Re: Building Recertification 600 BILTMORE WAY Folio # 03-4117-025-0001

BILTMORE II CONDOMINIUM BUILDING FORTY-YEAR INSPECTION

Biltmore II Condominium Building 600 Biltmore Way Coral Gables, FL 33134

Biltmore II Condominium Building Forty-Year Inspection Report

PHOTO # 1: Vertical cracking on building wall located at balcony Unit #219

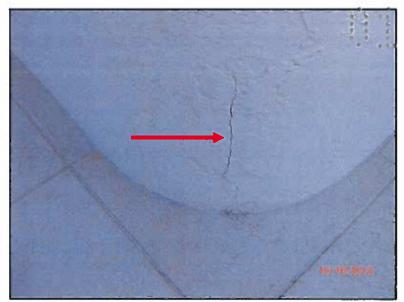
- 1. The building structure is generally in good condition.
- 2. The interior walls of balconies are in good condition overall. Minor cracking was observed on interior balcony wall and building wall (photo #1, photo #2 and photo #3) location.

The walls of the balcony slabs are typically in good condition, the inspected residential units' exhibit cracking at balconies. This is an indication of moisture intrusion into the block wall, with subsequent delamination of stucco. If left unabated, the stucco at the balcony block wall will eventually spall off, creating a falling debris and life safety hazard for residents and pedestrians below. We recommend the balcony walls be repaired where there are sign of cracking and delamination. In addition, we also recommend that all balcony block walls be surgeyed to document similar conditions.

PHOTO # 5: Concrete spalling at balcony ceiling at Unit #416

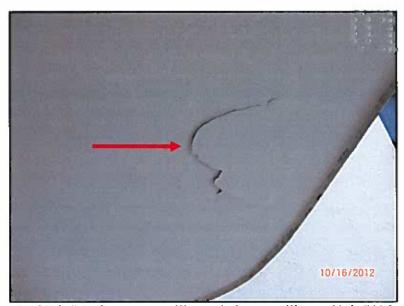
- 3. The balcony slabs are in fair condition. Spalled concrete with corroded reinforcing steel was noted on the balcony ceilings of Units 219 and 416 (photo #4 and photo #5).

Although the edges of the balcony slabs are typically in fair condition, some units exhibit cracking and concrete spalling at the slab edge and at the underside of slab above. This is an indication of moisture intrusion into the concrete, with subsequent corrosion of the reinforcing steel. If left unabated, the concrete at the edges of balconies will eventually spall off, creating a falling debris and life safety hazard for residents and pedestrians below. It's recommended that balcony edges be repaired where there are signs of cracking and concrete spalling. In addition, we also recommend that all balconies be surveyed to document similar conditions.

PHOTO #7: Cracking/delaminated stucco on balcony slab edge at Unit #407

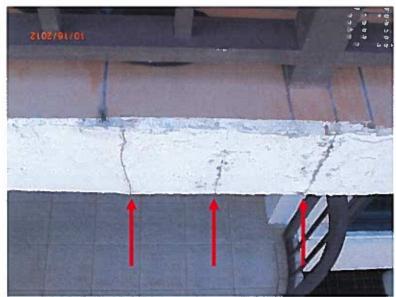
- 4. Minor stucco cracking at balcony railing connection to block wall of Unit 407 (photo #6).
- 5. We observed stucco cracking along balcony's edge of Unit 407 (photo #7) and connection between block wall and building column of Unit 219 (photo #8).

PHOTO # 9: Delaminated/cracking stucco at exterior of Generator Room at roof area

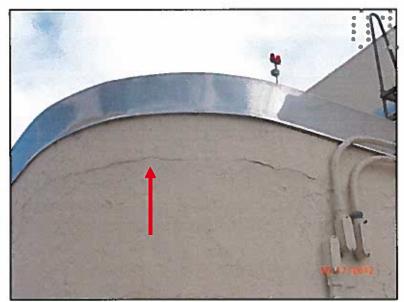
- 6. The roof edges of the Generator Room (photo #9) and East Elevator Machine Room (photo #10) at Roof Area have fine horizontal cracks which exhibit signs of water infiltration.

PHOTO # 12: Horizontal cracking at PH exterior wall

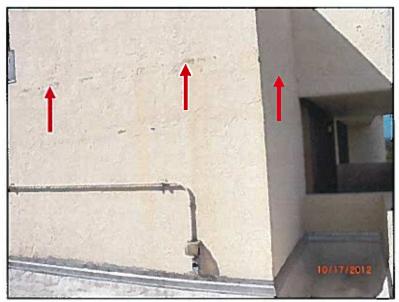
- 7. The interior block wall at the east side of the Elevator Machine Room at the Roof Area was observed with step cracking (photo #11).
- 8. The roof edge of the Penthouse exterior wall (photo #12) was noted with fine horizontal cracks which exhibit signs of water infiltration.

PHOTO #15: slab cracking at column drop panel next to Parking Space No. 267

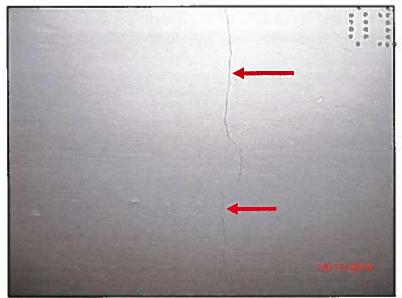
- 9. The interior block wall at the West Elevator Machine Room is not mortared properly at patched area (photo #13).
- 10. Hair Line cracking across column drop panel next to Parking Space No. 267 (photo #14 and photo #15).

PHOTO # 16: Unsealed wall, pipe penetration at Fire rated assembly (2hr fire rated assembly)

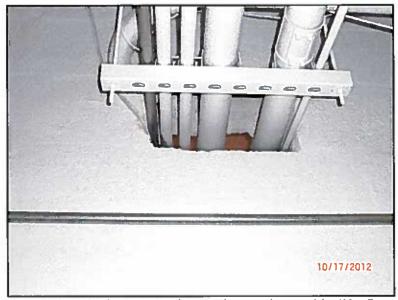
- 11. Unscaled wall pipe penetration at fire rated separation (2hr Fire rate assembly) (photo #16).
- 12. Hair line cracking on slab and beam was noted next to Parking Space No. 210 (photo #17 and photo #18).

PHOTO # 20: slab cracking at column drop panel between Parking Spaces 245 & 246

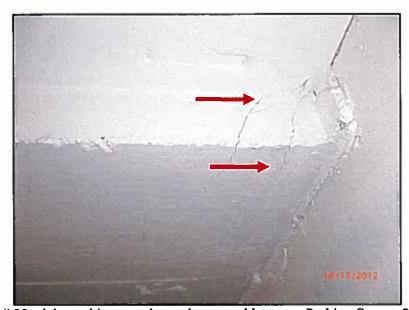
- 13. Hair line cracking across column drop panel between Parking Space No. 248 & 249 (photo #19).
- 14. Hair Line cracking at column drop panel corner between Parking Space No. 245 & 246 (photo #20).

PHOTO # 22: trench drain drop ceiling opening between Parking Spaces 314 & 327

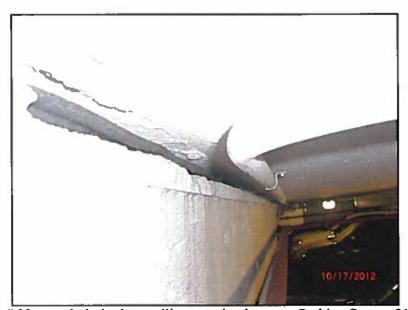
- 15. Trench drain drop ceiling opening over flows at opening between Parking Spaces No. 314 & 327 (photo #21 and photo #22).
- 16. Surface cracking and water intrusion was noted at underside of ramp on front of Parking Space No. 61 (photo #23).

PHOTO # 25: trench drain drop ceiling between Parking Spaces 52 & 61

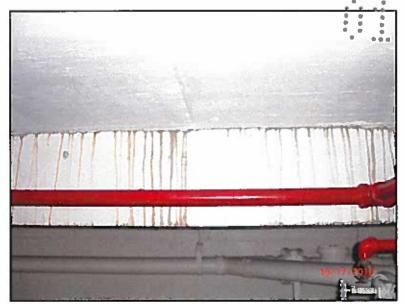
- 17. Trench drain drop ceiling opening over flows at opening between Parking Space No. 52 & 61 (photo #24 and photo #25).
- 18. The East end of the Parking Garage wall exhibits hair line cracking next to Parking Space No. 51 (photo #26).

PHOTO # 27: Unsealed wall, pipe penetration at Fire rated assembly (2hr fire rated assembly)

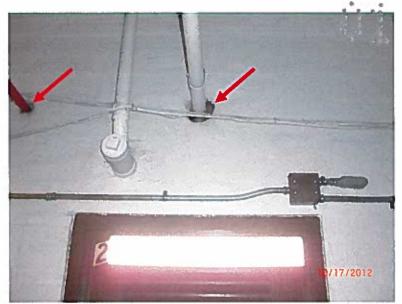
- 19. Unsealed wall pipe penetration at fire rated separation (2hr Fire rate assembly) above Fire Pump Room door (photo #27).
- 20. Hair Line Cracking on Overhang at West side (photo #28).

PHOTO # 30: cracking & blistering at underside of overhang edge

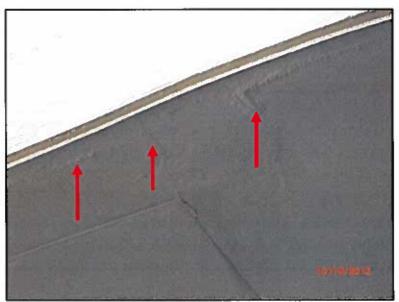
- 21. Hair Line Cracking and staining on balcony edge at Third level on north side (photo #29).
- 22. Blistering and underside cracking was observed at Overhang (photo #30).

PHOTO #31: stucco cracking at bottom of third floor balcony wall on East side

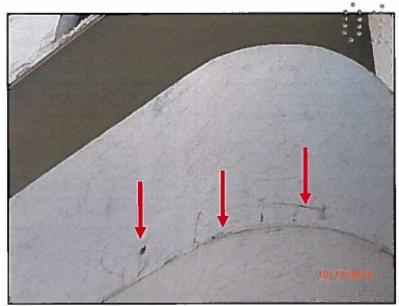
- 23. Cracking at bottom of balcony wall was noted (photo #31).
- 24. Crack along tiled pedestrian ramp east of main entrance was observed (photo #32).
- 25. Delaminated stucco and cracking at bottom of fourth floor balcony wall on east (photo

PHOTO # 34: stucco cracking on building wall next to east stairs tower

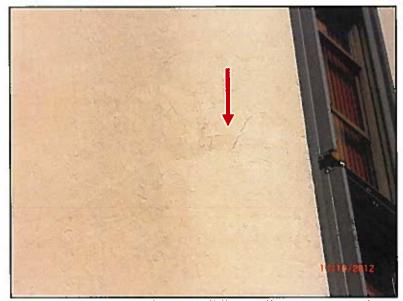
- 26. Surface cracks on building shear wall next to window shutter next to east stairs tower (photo #34).
- 27. Spider web cracking on exterior face at first balcony on East side (photo #35).

PHOTO # 36: ceiling separation at edge of South overhang

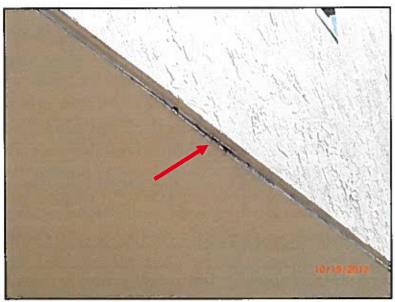
- 28. Ceiling panel separation at edge of South overhang (photo #36).
- 29. Stucco cracking on East side of building corner at Pool Deck Area (photo #37).
